### APPEAL SUMMARY

<b>Appeal ID:</b> 20773	<b>Project Address:</b> 200 NW Royal Blvd, Lot #4
<b>Hearing Date:</b> 8/21/19	<b>Appellant Name:</b> Robert Oshatz
<b>Case No.:</b> B-009	<b>Appellant Phone:</b> 5036354243
<b>Appeal Type:</b> Building	<b>Plans Examiner/Inspector:</b> Jason Butler-Brown
<b>Project Type:</b> residential	<b>Stories:</b> 3 <b>Occupancy:</b> R <b>Construction Type:</b> V-B
<b>Building/Business Name:</b> RHO LLC	<b>Fire Sprinklers:</b> No
<b>Appeal Involves:</b> Erection of a new structure	<b>LUR or Permit Application No.:</b> 06-109711-LU
<b>Plan Submitted Option:</b> pdf [File 1] [File 2]	<b>Proposed use:</b> Single family residence

**Code Section** R302

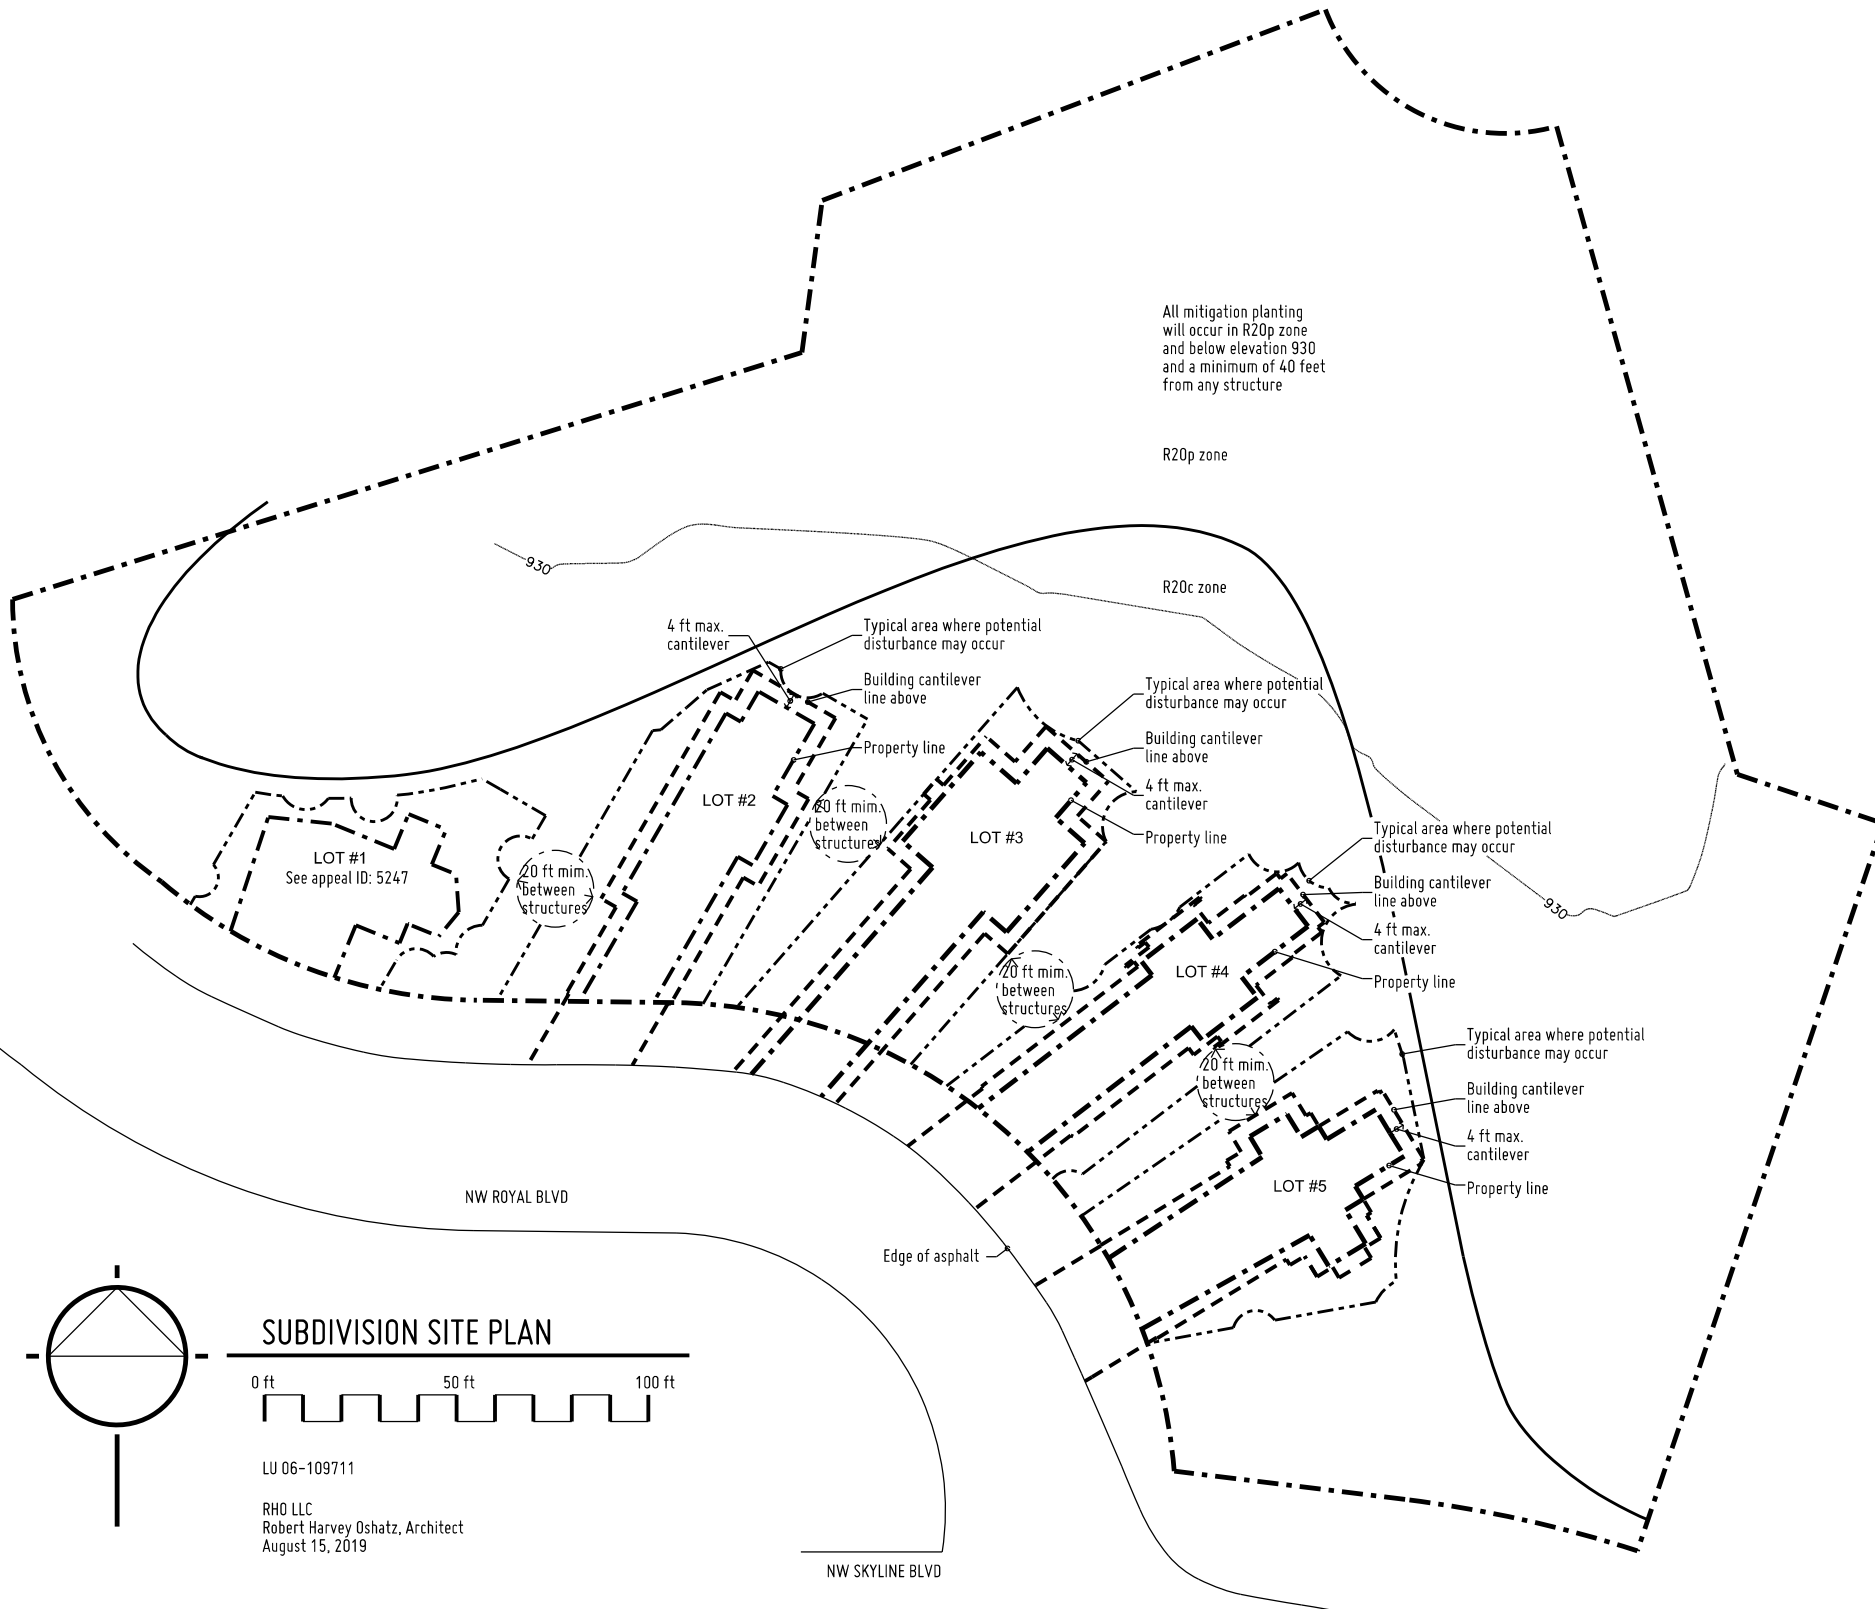
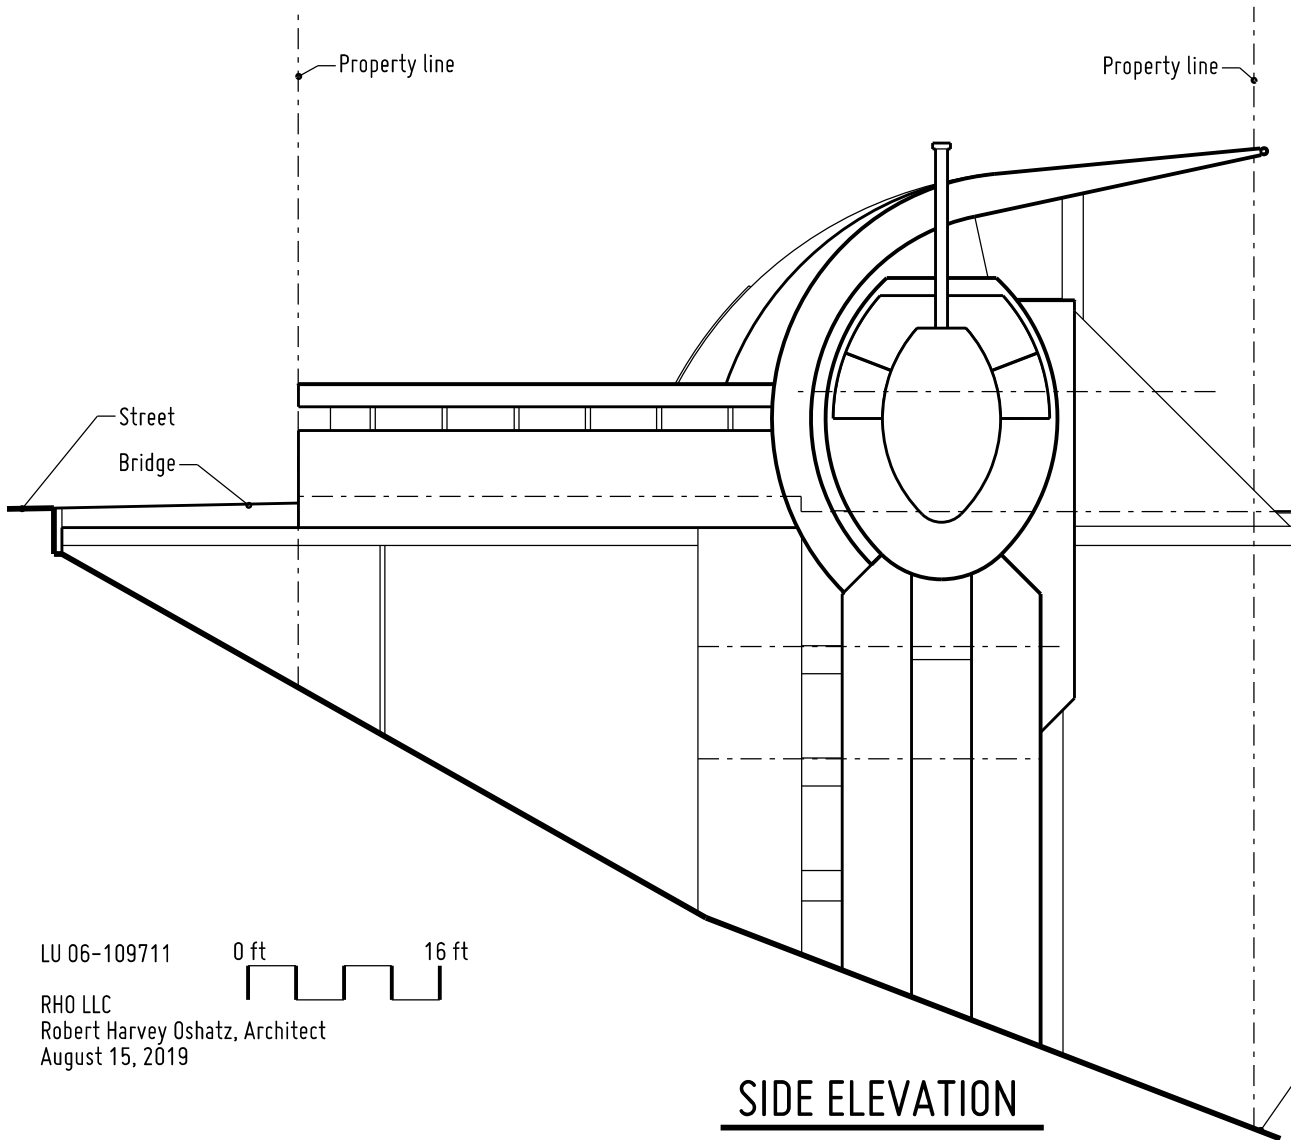
**Openings in exterior walls at property line: Hold for additional information.**  
**Appellant may contact John Butler (503 823-7339) with questions.**
